ERRATA

**1992 Formula
Operator's Guide**

Concerning Formula MX XTC/R Only

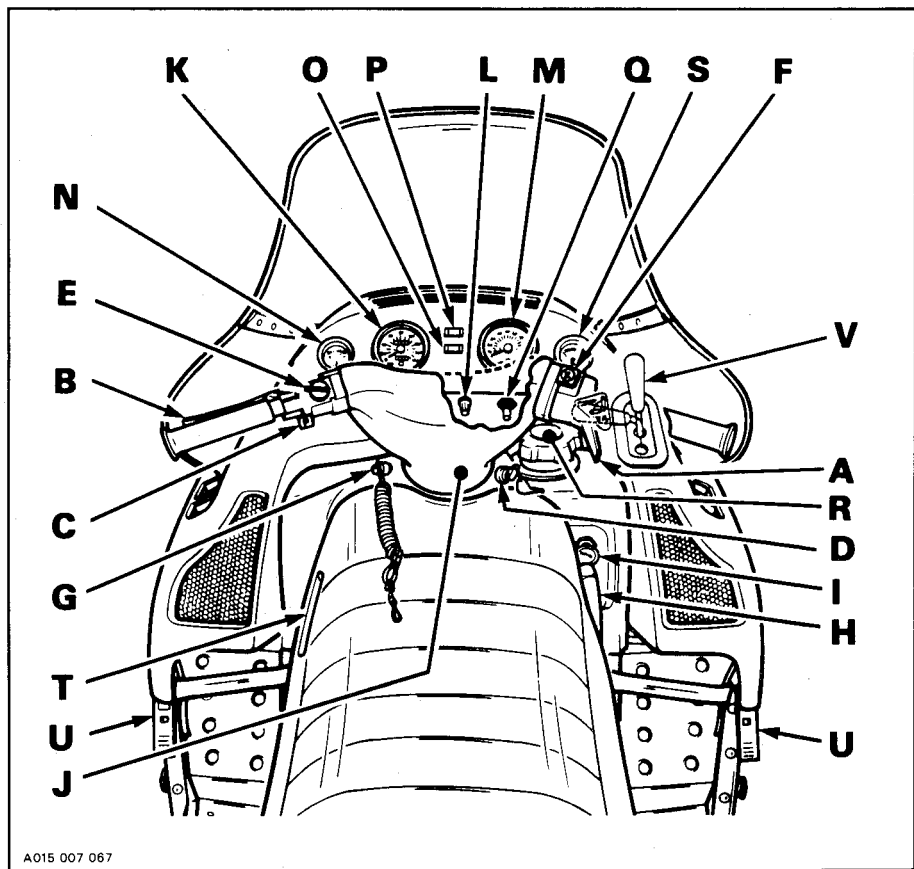
The illustration should show as follows :

**V) Gear Shift Lever
(models with reverse
gear only)**

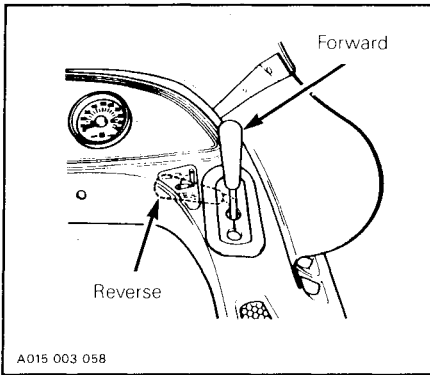
V paragraph should read as follows :

With machine fully stopped and engine at idle, turn lever right or left to engage forward or reverse gear.

Do not force into reverse. If not able to shift to reverse, apply throttle to move vehicle and try again.

▼ **CAUTION** : Bring vehicle to complete stop before changing gear.

◆ **WARNING** : This snowmobile is capable of a fast reverse. On first outing, operator should become familiar with this operation by practicing on level ground. Ensure the path behind is clear of obstacles or bystanders. Fast reverse, while turning, could result in loss of stability.

◆ **WARNING** : Before starting engine, check that lever is in forward position.

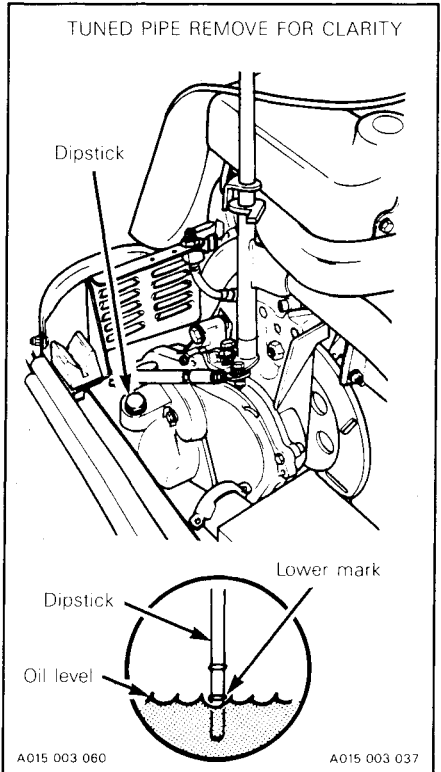
Replace **Chaincase Oil Level** paragraph by : **Gearbox Oil Level**.

With vehicle on a level surface, check the oil level by removing dipstick. With dipstick **unscrewed**, oil level must be at **lower** mark. Refill as required using BOMBARDIER synthetic chaincase oil (P/N 413 8026 00 - 250 mL (9 oz)).

○ **NOTE** : The gearbox oil capacity is approximately 400 mL (13.5 oz).

Gear Shift Lever

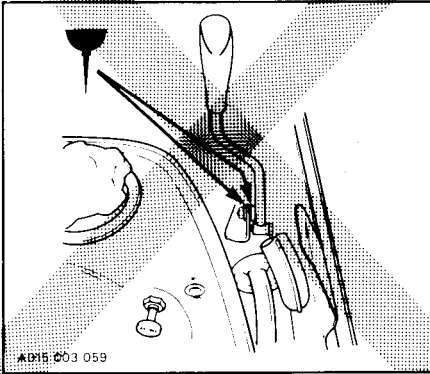
Oil moving parts once a year.
